Company	Trenz Electronic GmbH
PCN Number	PCN-20190827
Title	TE0706-03 Under Voltage Protection Change
Subject	Trenz Electronic TE0706 Hardware Change
Issue Date	2019-09-05

affected product
TE0706-03

#1 Replaced R34 by 953kOhm and R38 by 147kOhm

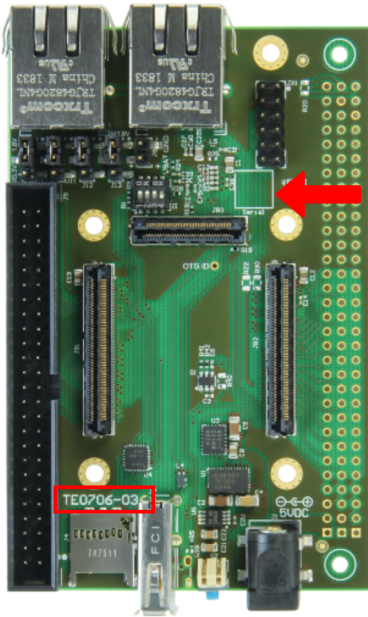
Type: BOM change

Reason: Large start up currents led due to adverse conditions (e.g. weak powersupply, long wires, increased contact resistance) to a voltage drop below the under voltage lock out limit of the input protection circuit.

Impact: Under voltage protection limit is decreased to 4.06V, which gives a larger margin for a voltage drop during start up.
